Southern Nuclear Operating Company
Vogtle Electric Generating Plant Units 3 and 4 Combined License Application
Second Supplemental Response to Request for Additional Information Letter No. 18

Second Supplemental Response to RAI 03.07.02-1

FSAR Section 3.7, Seismic Design

Revised FSAR Appendix 3GG

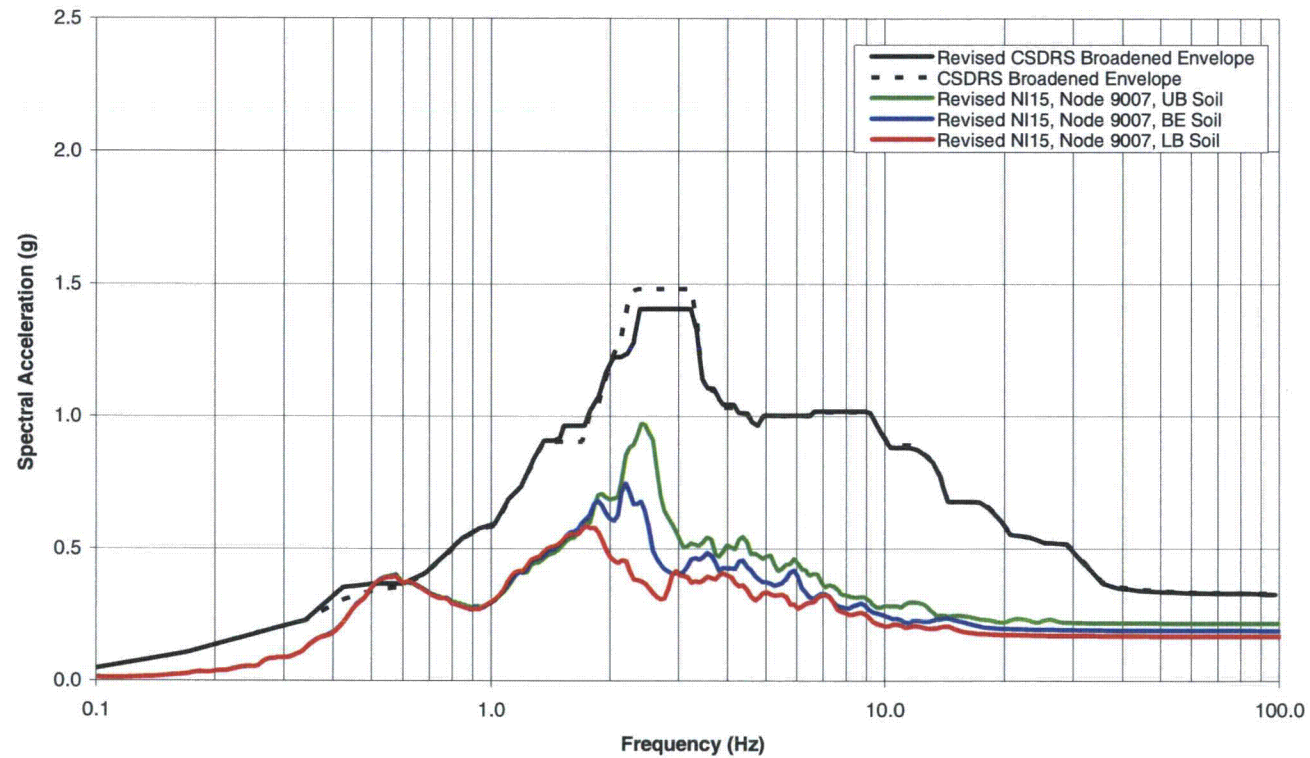
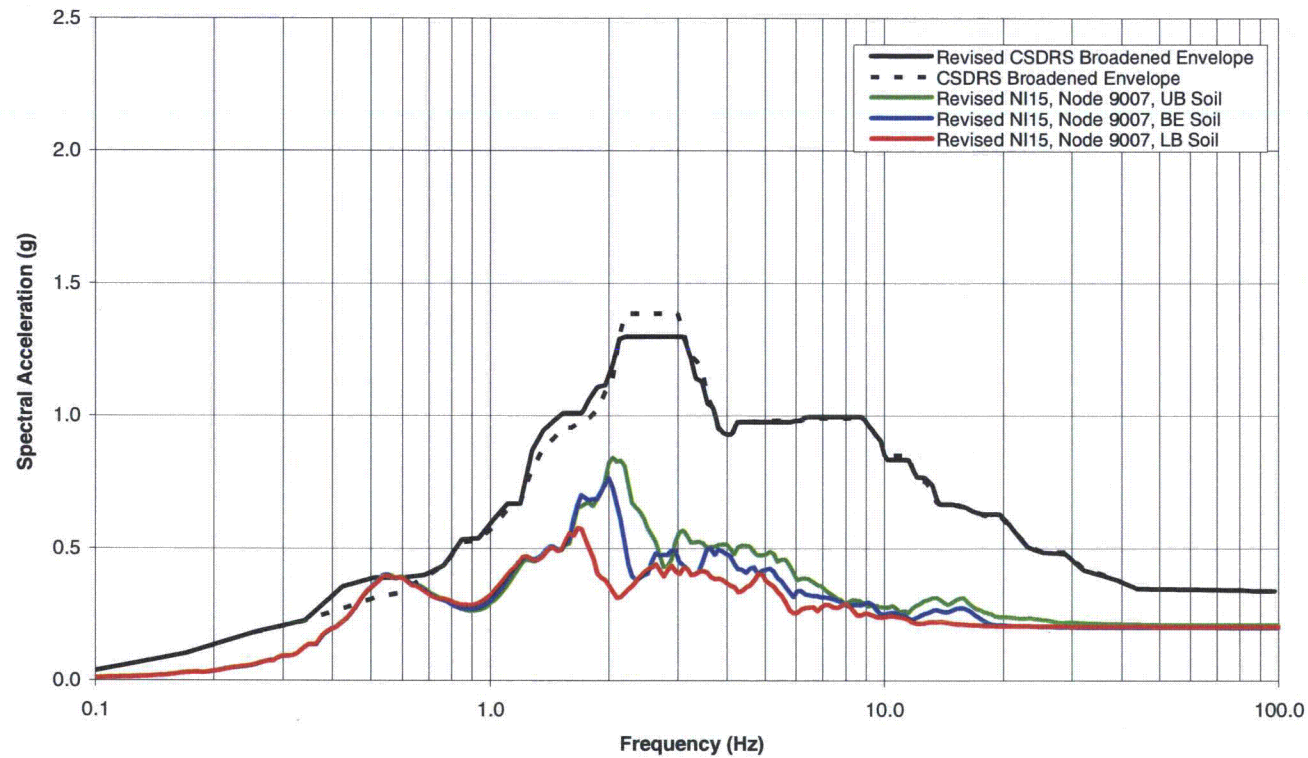
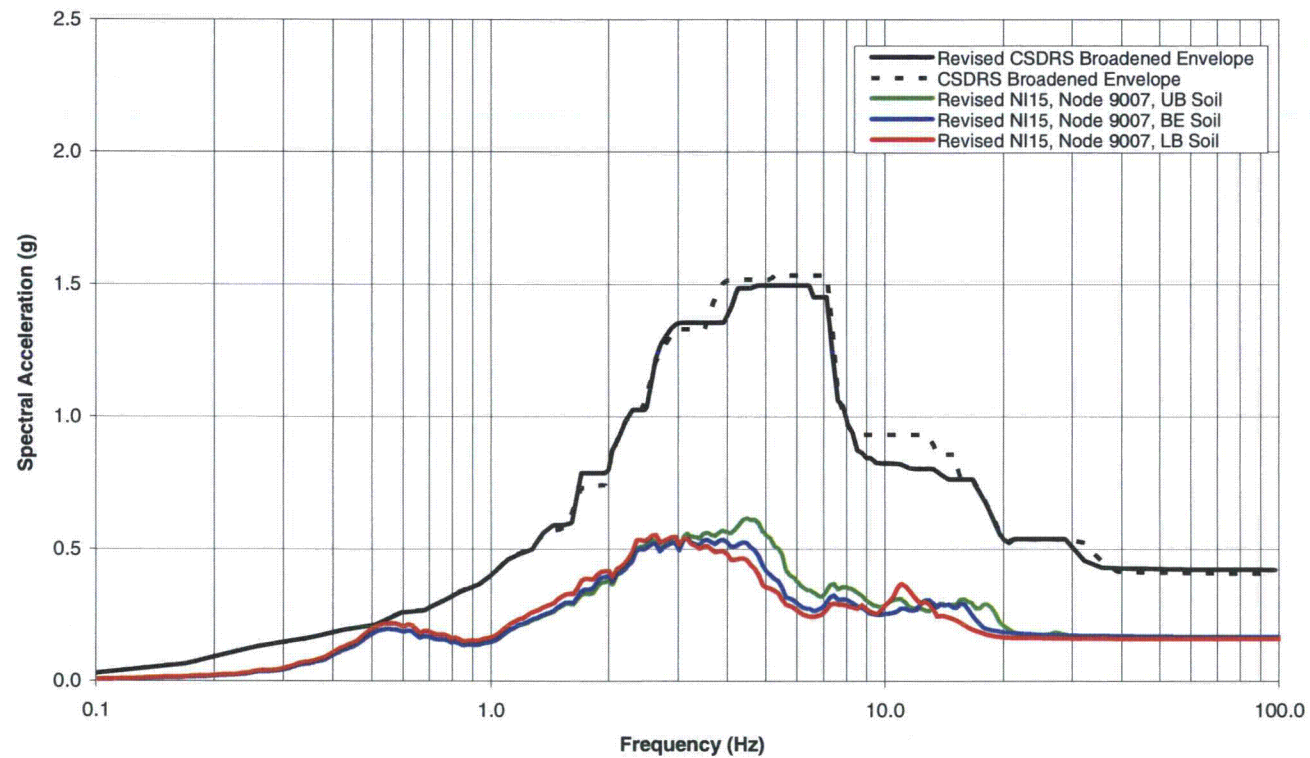
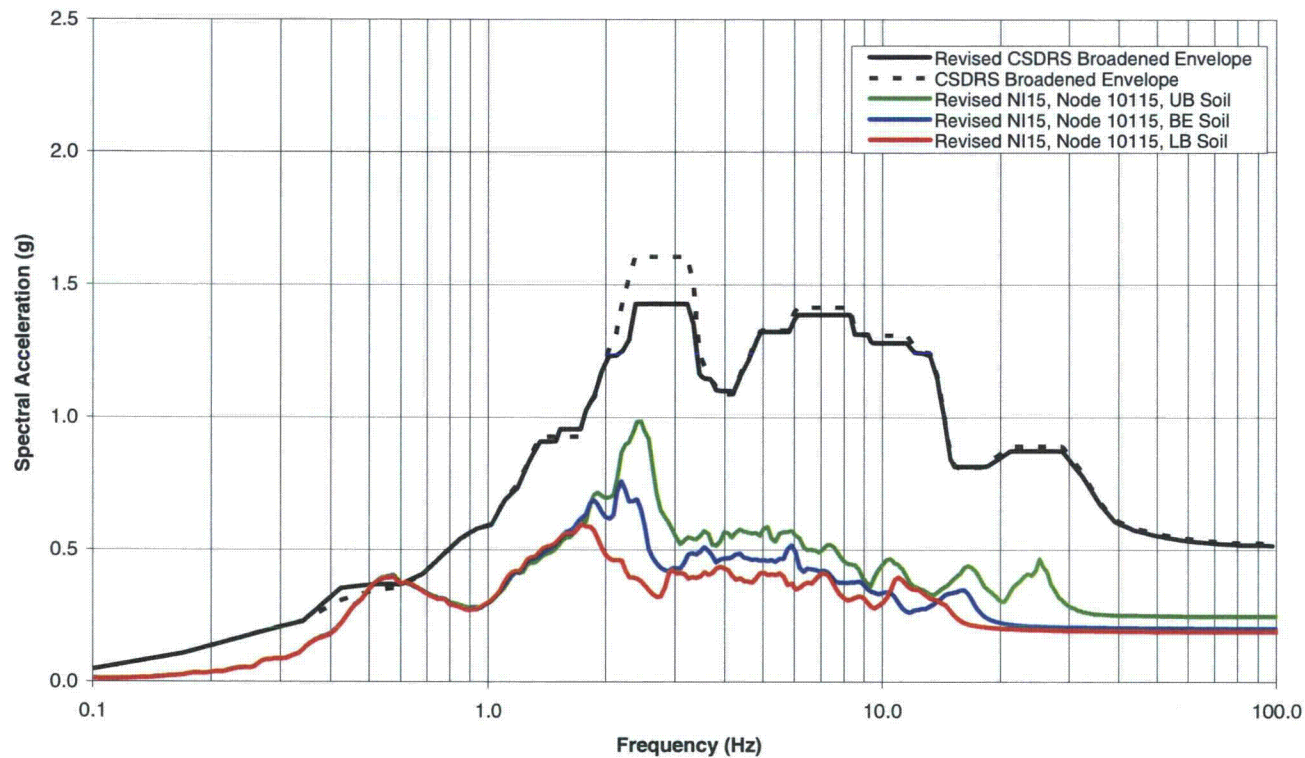
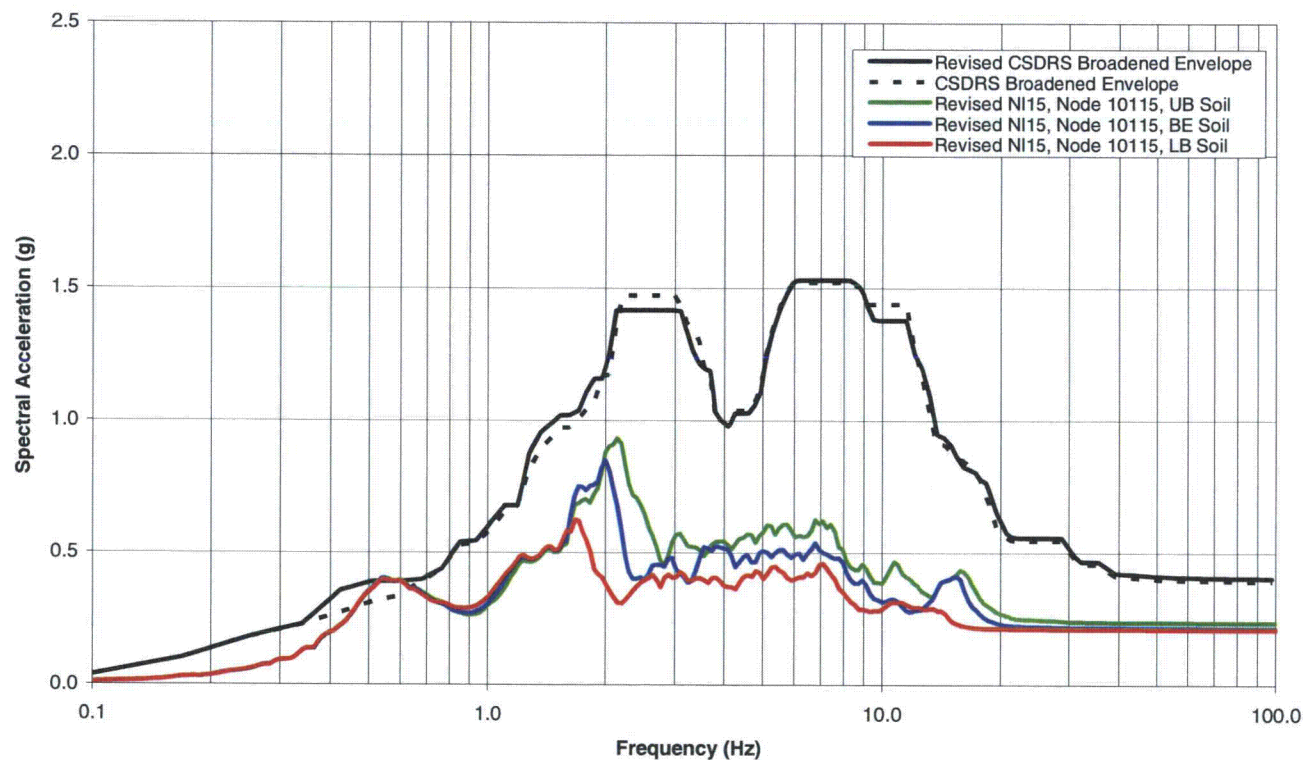
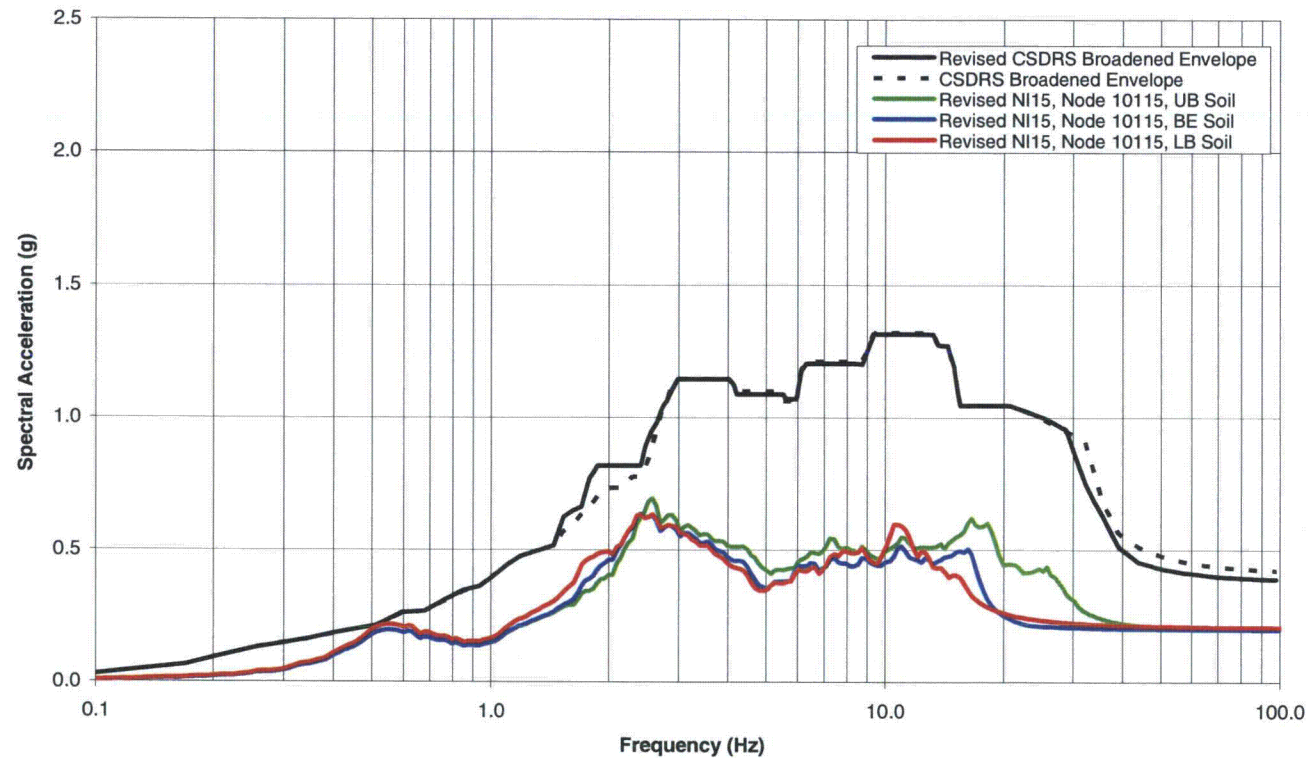
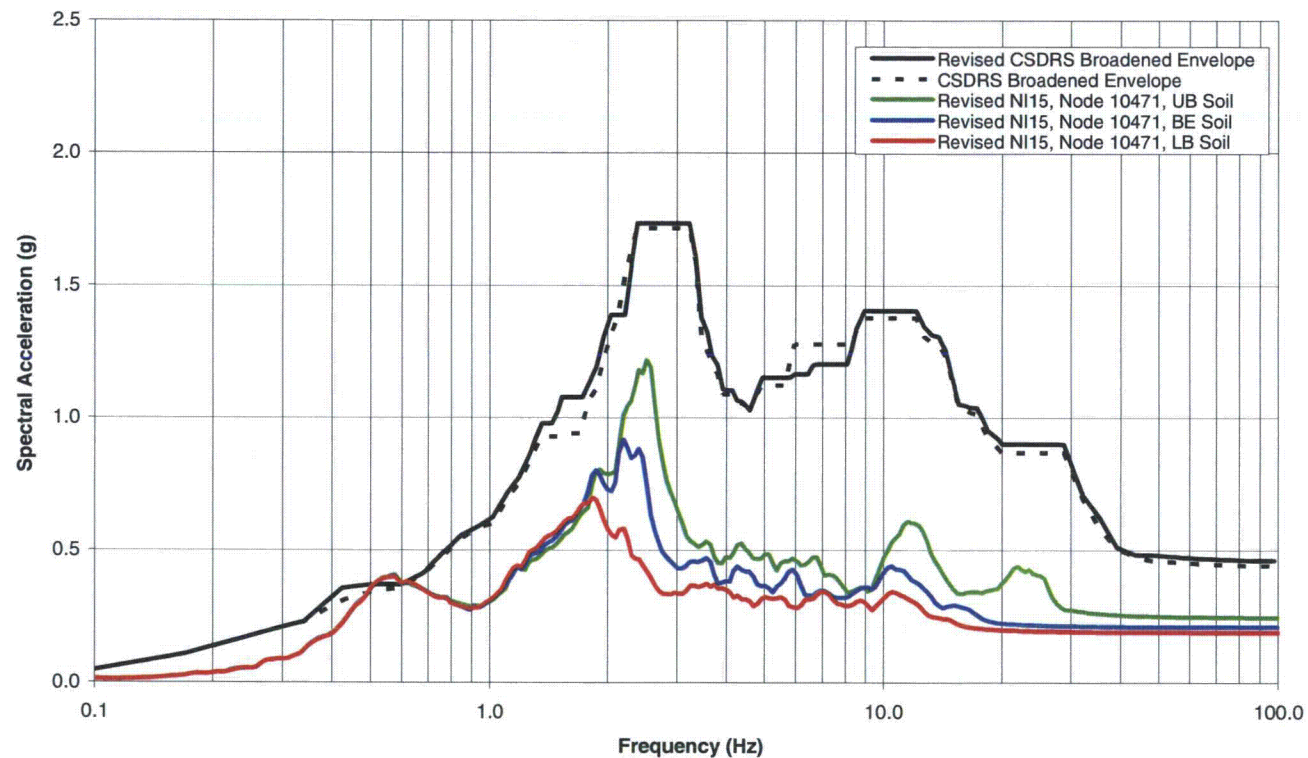
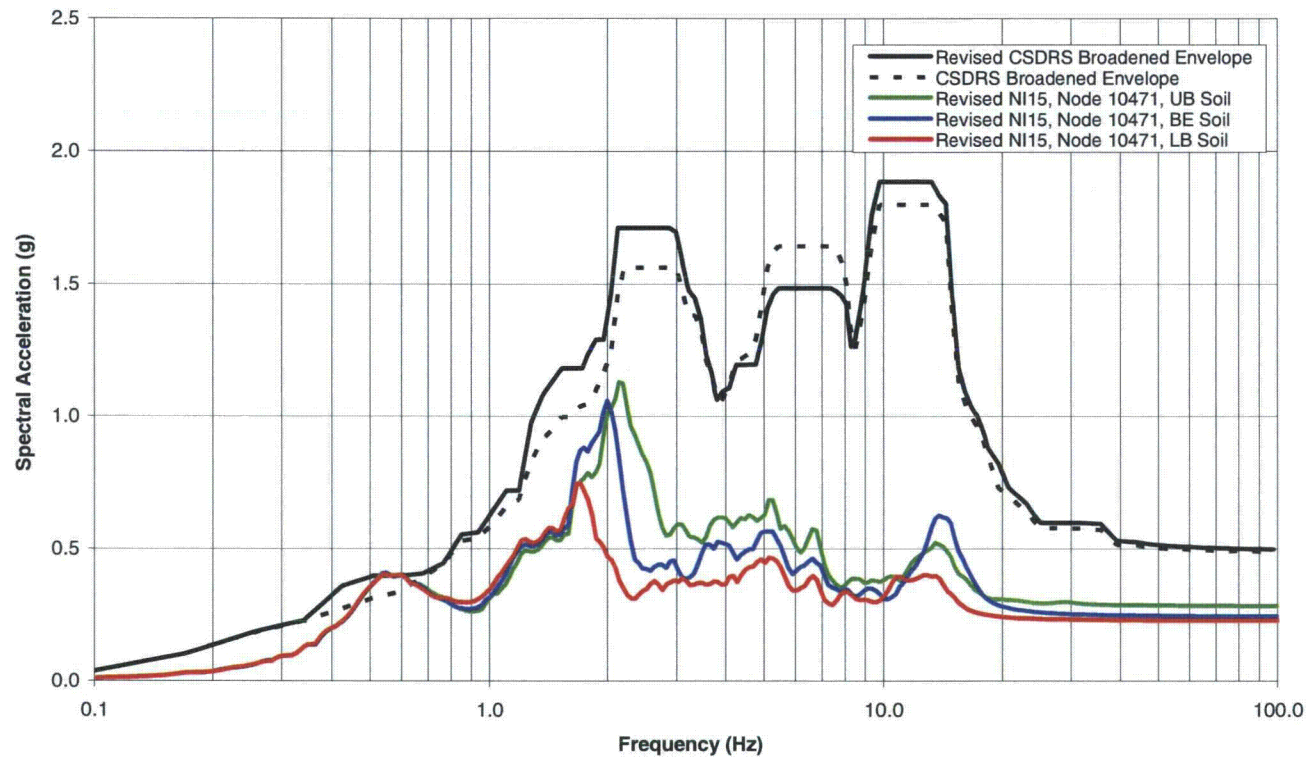
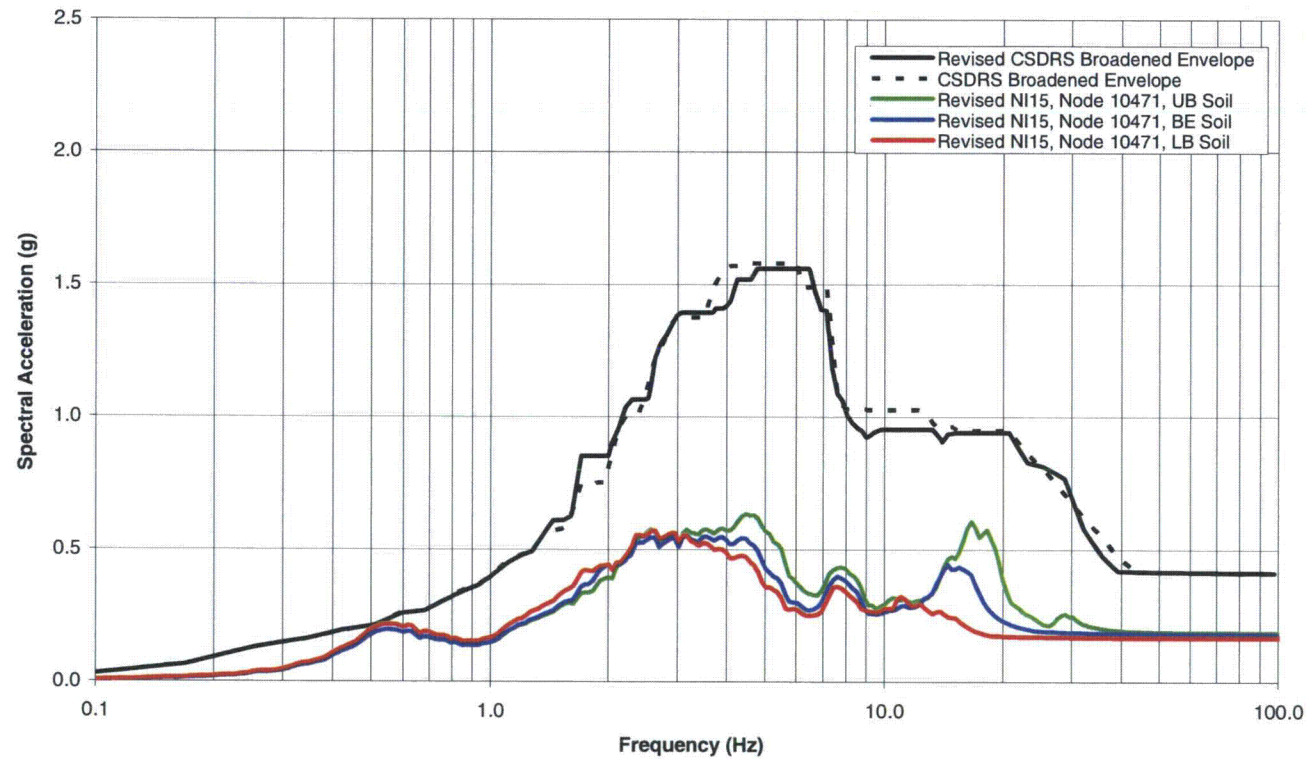
Please justify the adequacy of the 2D SASSI response analysis in light of the magnitude of the vertical response in the 3D SASSI detailed response analysis models.

Enclosure 2 to this letter provides a proposed FSAR Appendix 3GG revision, which shows the 5% damped Vogtle ISRS compared to the revised AP1000 CSDRS broadened envelope ISRS at the six key locations. For a point of reference, the comparisons also include the original AP1000 CSDRS broadened envelope ISRS to aid in understanding the differences in the revised ISRS comparisons. This proposed FSAR revision will be incorporated into a future version of the VEGP Units 3 and 4 COL Application.

1. The revised Vogtle NI15 SASSI ISRS are almost identical to the original Vogtle NI15 SASSI ISRS provided in the supplemental response to RAI 3.7.2-1, especially in the lower frequency range below 10 Hz.
2. The revised AP1000 CSDRS broadened envelope ISRS at the six key locations (Ref. 1) has changed such that above 1 Hz there are now no exceedances of these AP1000 CSDRS broadened envelope ISRS by the revised Vogtle NI15 SASSI ISRS. Below 1 Hz, there is exceedance near 0.55 Hz as before; but now the amount of the exceedance is much less and primarily only in the X direction.
3. The exceedances near 0.55 Hz have been addressed previously where they were shown to have no impact on the AP1000 design.

As shown in these figures, the “design envelope” exceeds the site specific response motions basically over the entire range of frequencies and by a large margin. This margin is particularly large at the zero period acceleration level indicating a large margin for seismic member forces. At a very limited frequency range, small exceedances beyond the design envelopes are observed. The exceedance at about 0.55 Hz is consistent with the previous two-dimensional SSI results and has no design consequence since there are no structural members at this frequency.
